SERVICE INFORMATION

EFI / MPI Fuel Pumps With Low Pressure

Models

76328

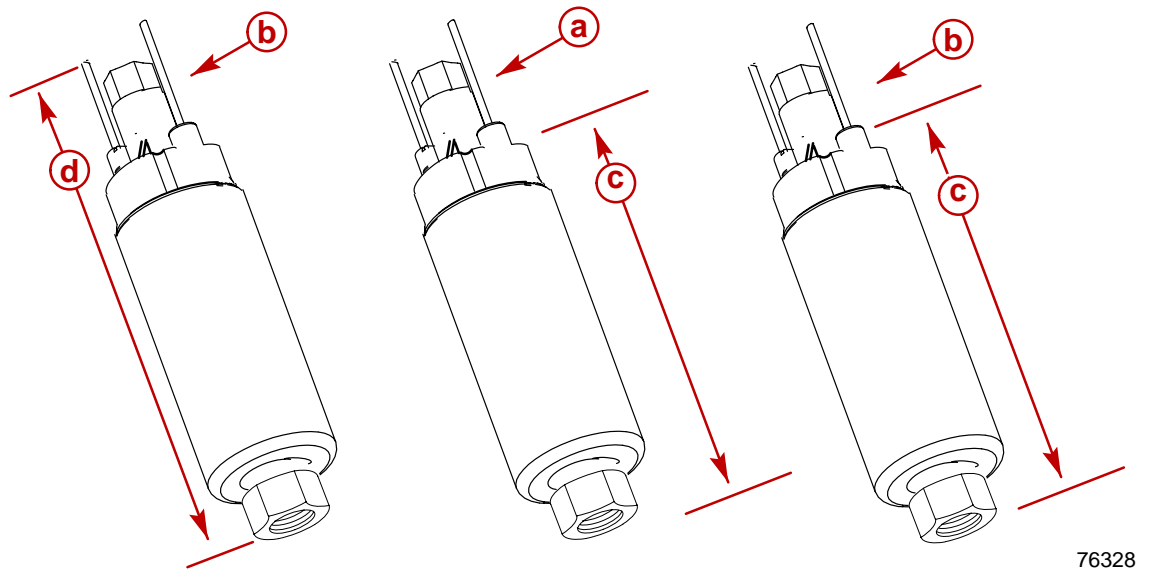
Engines within the serial number ranges listed may be equipped with an electric fuel pump that is painted black with a brass outlet. Under certain conditions, the check valve in the brass outlet of this pump may 'cock'. This will cause low pump pressure above 4000 rpm and a loss of engine performance.

NOTE: Painted pumps with an aluminum outlet or unpainted pumps with the brass outlet have a different style check valve and spring that will not 'cock'. Refer to the drawing.

If one of the engines listed has a loss of power above 4000 rpm, use a fuel pressure gauge to measure the fuel pump pressure. Any reading below 22 psi (152 kPa) at 4000 rpm and above would indicate this check valve problem. Also, a 0 reading on the pressure gauge shortly after shutting the engine off is another indication.

Remove cover from the cool fuel assembly to see if the fuel pump is one that may have the check valve problem.

Suspect

Replace fuel pump with new one and retest pump pressure.

(1) 861156A 1 Fuel Pump Assembly.
